BID CLARIFICATION No. 2

Re: Bedford UFSD
Phase 2 – Bond Improvements at
Fox Lane High School, Fox Lane Middle
School, Administration Building
BBS File No. 23-131a-c

1. 23-131a, b, & c Construction Implementation Plans (CIPS)

CIP0.01

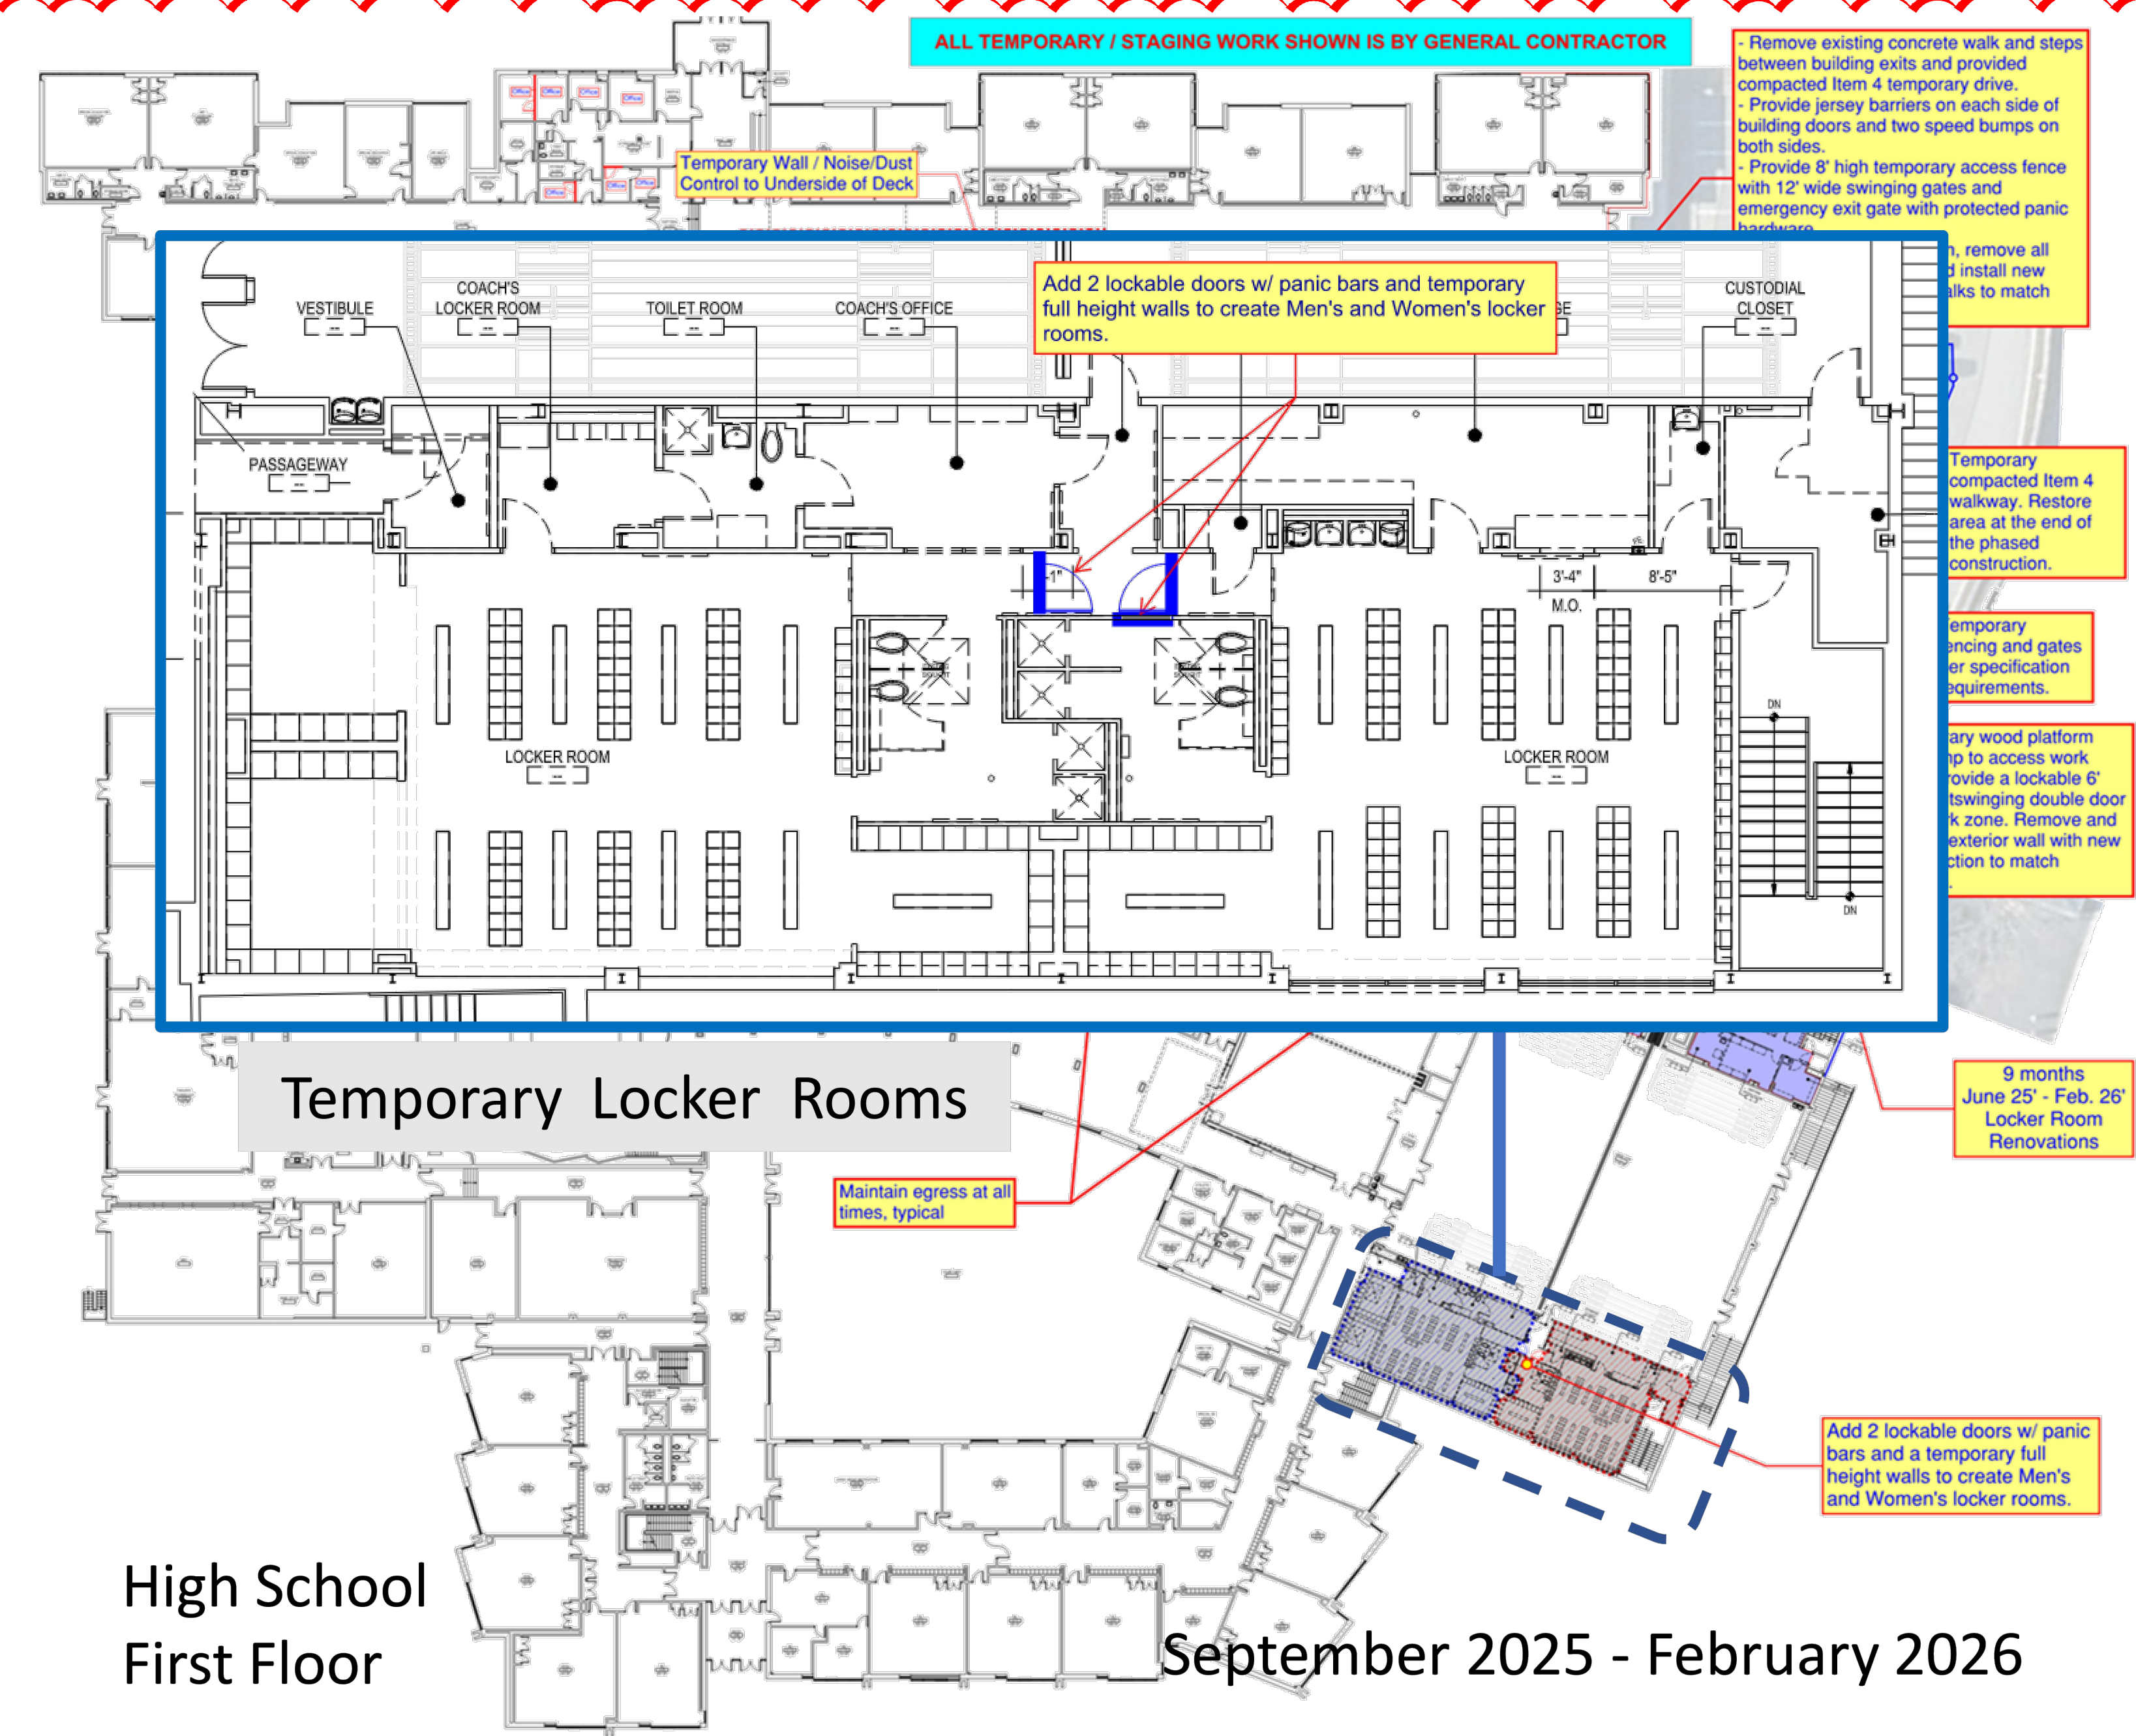
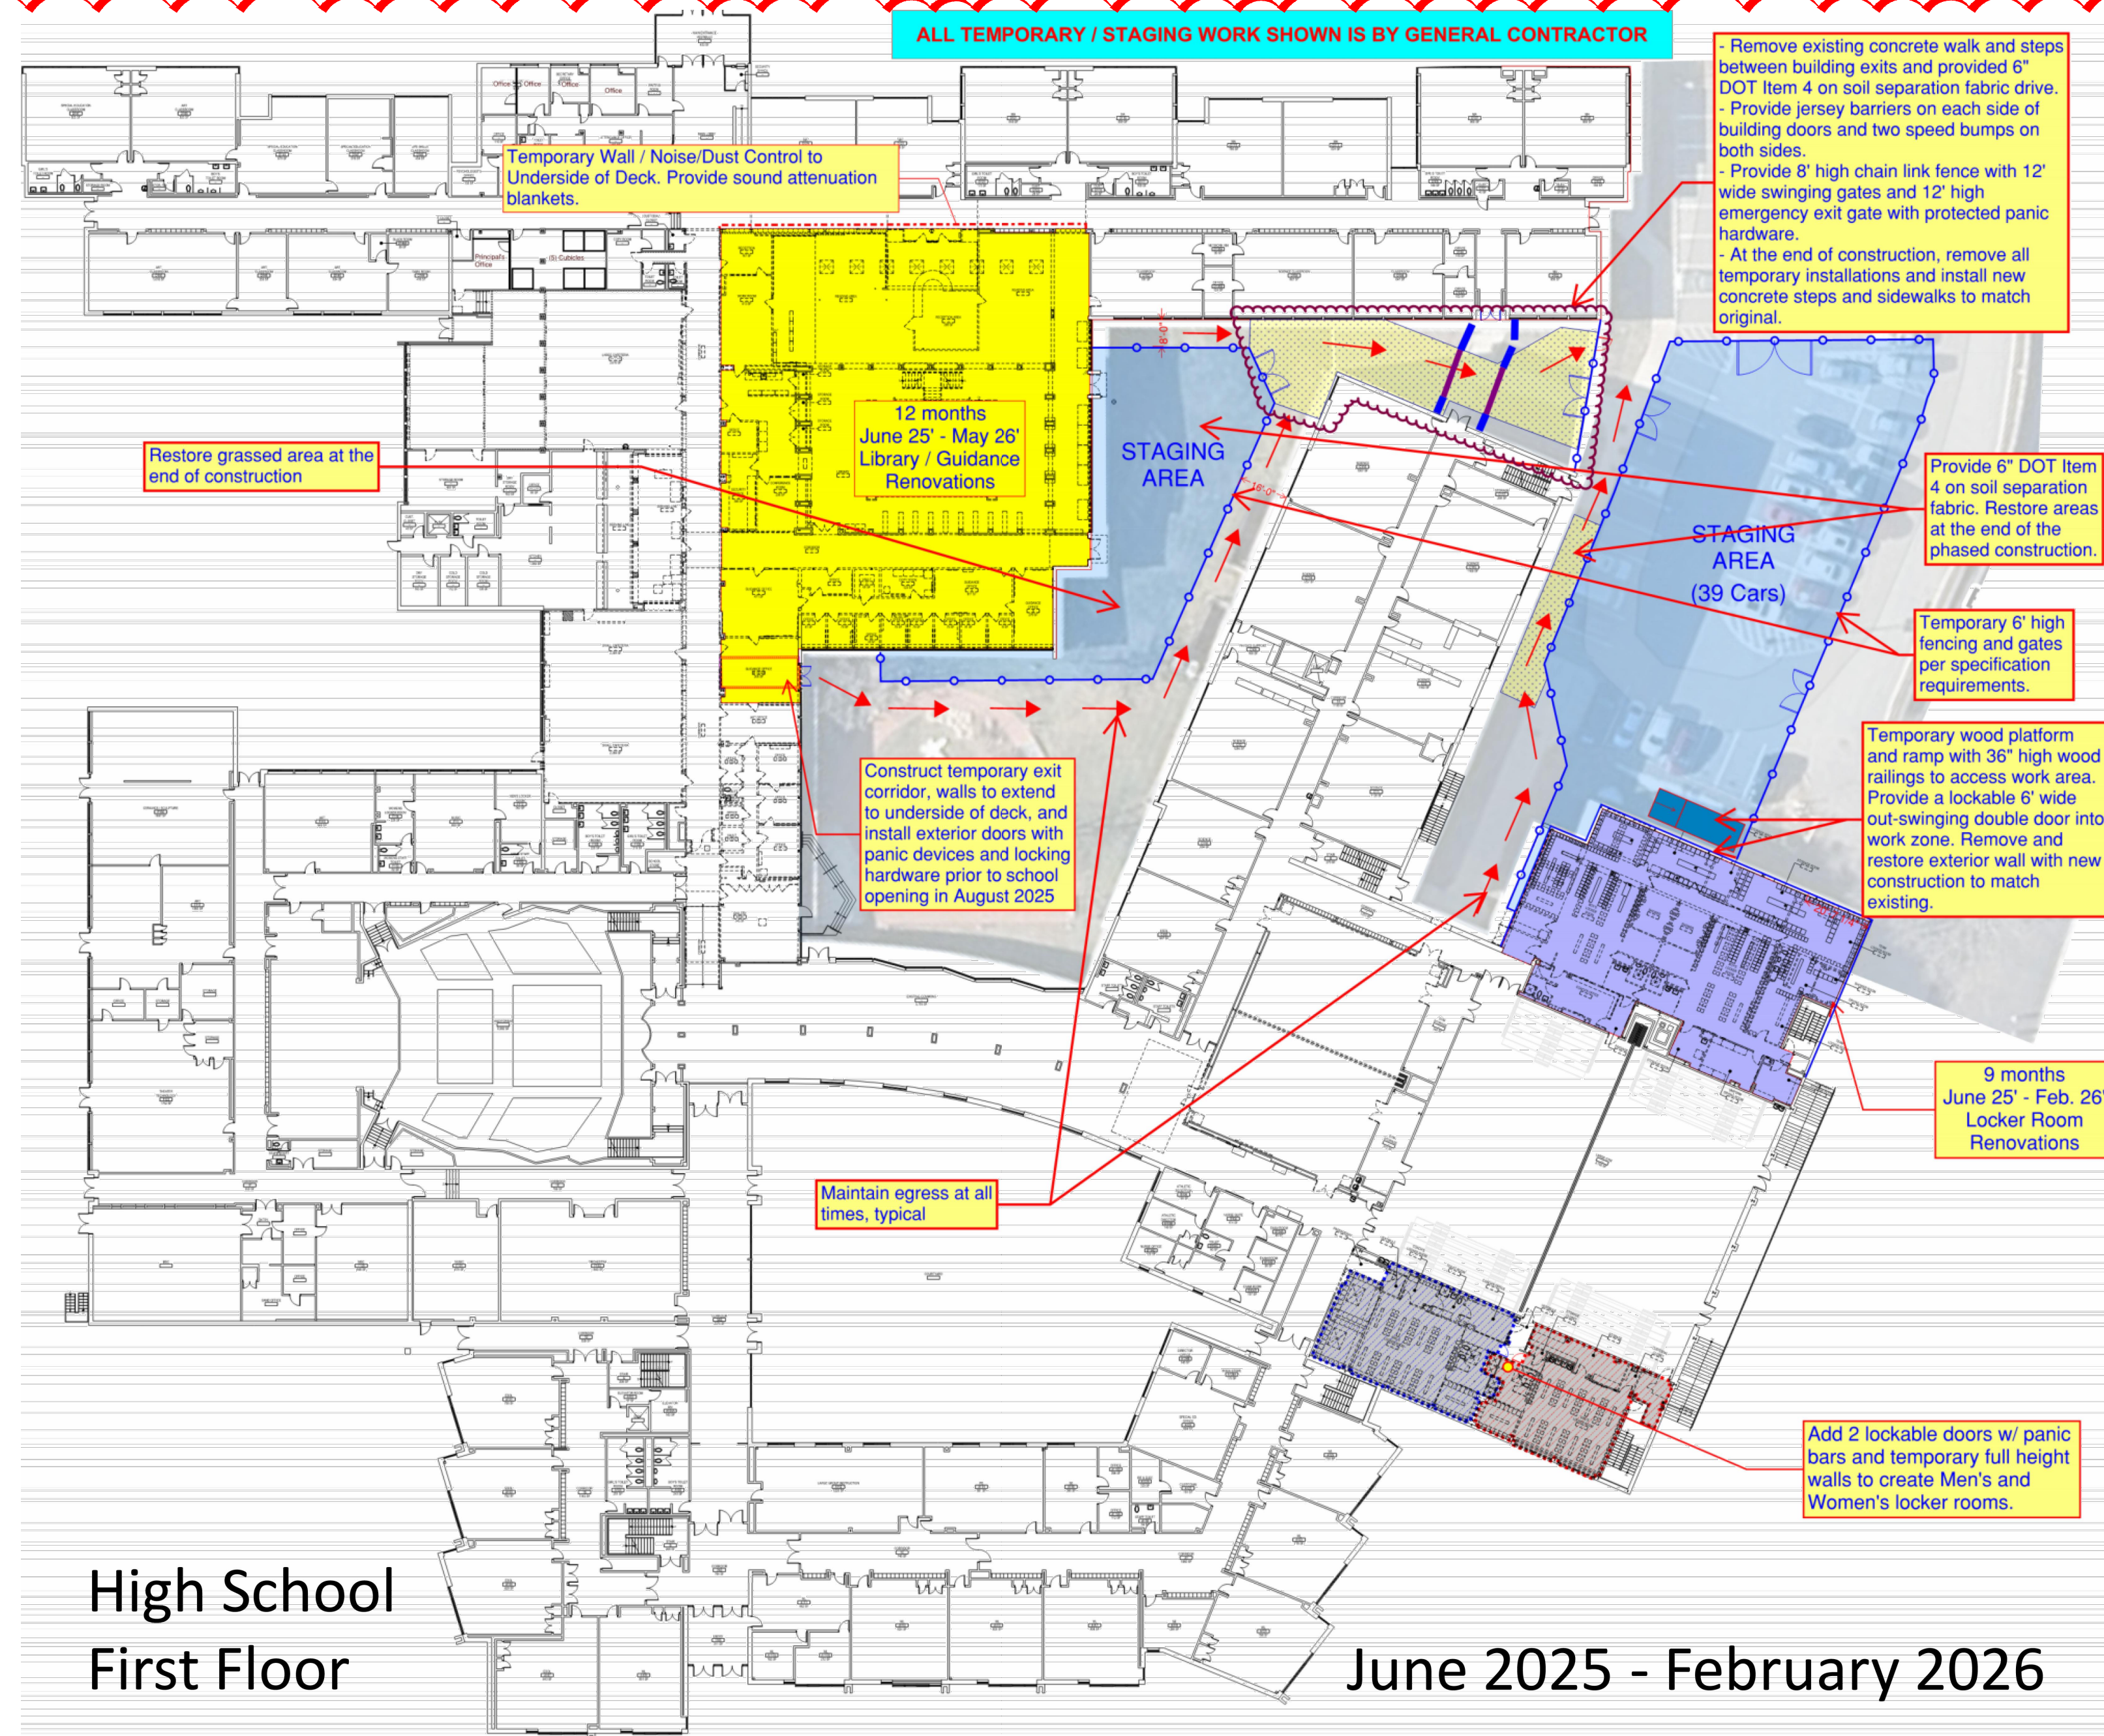
- a. The Construction Implementation Plans (CIPS) included in this clarification shall supercede the previously issued documents and all scope of work shown shall be included as part of the general contractor's base bid.
